Submissions received on Richmond Area street renewals, November 2021

Proposed Refurbishment of Nicholls Street Christchurch 2021

Concerning the proposed Renewal of Nicholls Street Outlined in the document “Richmond Area Street Renewals”

Filename: Nicholls Street Refurb 1

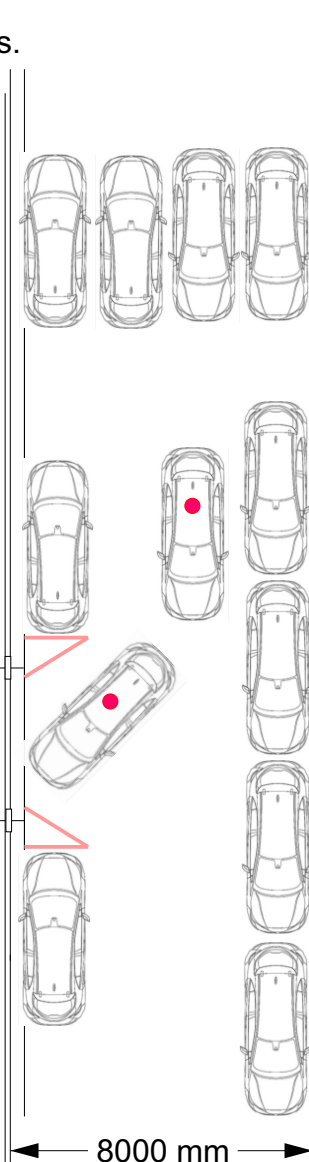
The cars shown are about 1900 mm wide over the mirrors.

Toyota Corolla (2021 Model) size is 1780 mm wide **without mirrors** x 4630 mm long.

The separation between four Corollas as shown would be approximately 292 mm **with the mirrors folded in.**

Allowing 60mm per mirror, 120 mm per car, for the **mirrors folded out** the separation would be $292 - 120\text{mm} = 172\text{mm}$

Scaled to 8,000 mm between curbs.

Very tight turning into drive or reversing out into street if vehicles are parked over the 3.5 meter minimum crossing width or the orange triangles.

In the Richmond Area Street Renewals Document "Ghost" cars were parked along the curb. That gave the impression of more space than there would be.

Scale: as shown
 Drawn by: RLP
 Date: 04/11/2021

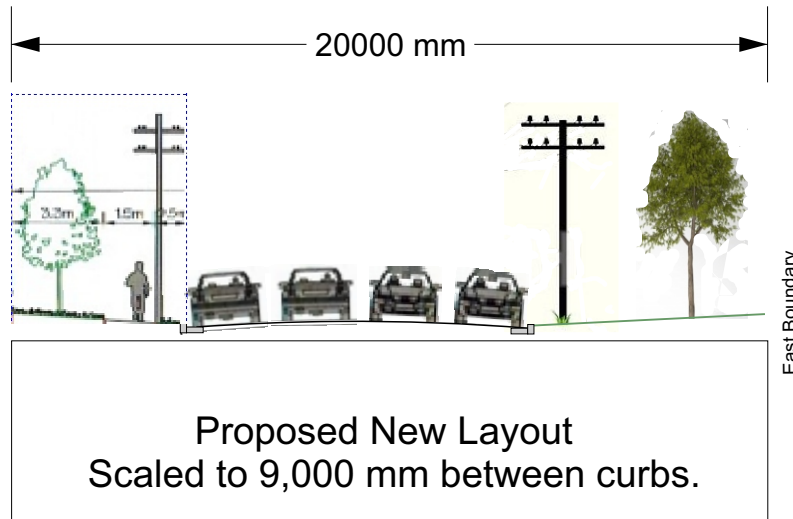
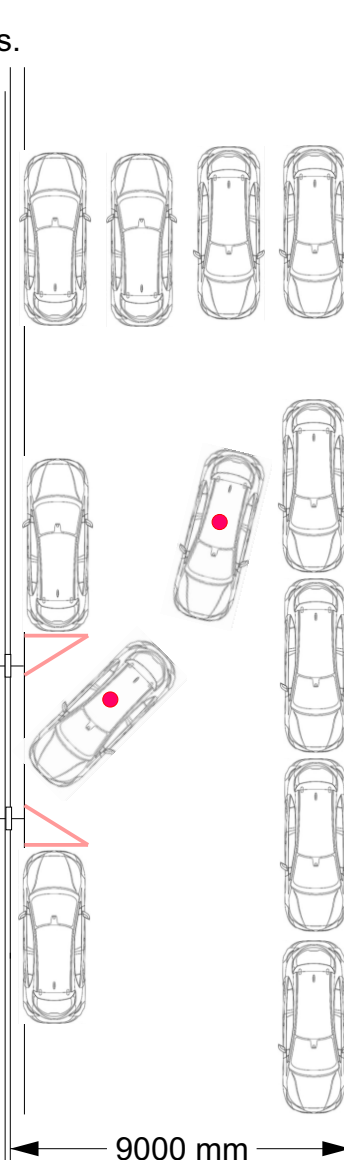
The cars shown are about 1900 mm wide over the mirrors.
 Toyota Corolla (2021 Model) size is 1780 mm wide **without mirrors** x 4630 mm long.
 The separation between four Corollas as shown would be approximately 627 mm **with the mirrors folded in**.
 Allowing 60mm per mirror, 120 mm per car, for the **mirrors folded out** the separation would be $627 - 120 \text{ mm} = 507 \text{ mm}$

Scaled to 9,000 mm between curbs.

Turning into drive or reversing out into street easier than with street width reduced to 8,000 mm.

Vehicles parked over the 3.5 meter minimum crossing width or the orange triangles (both prohibited) severely limit ease of access to the residential property.
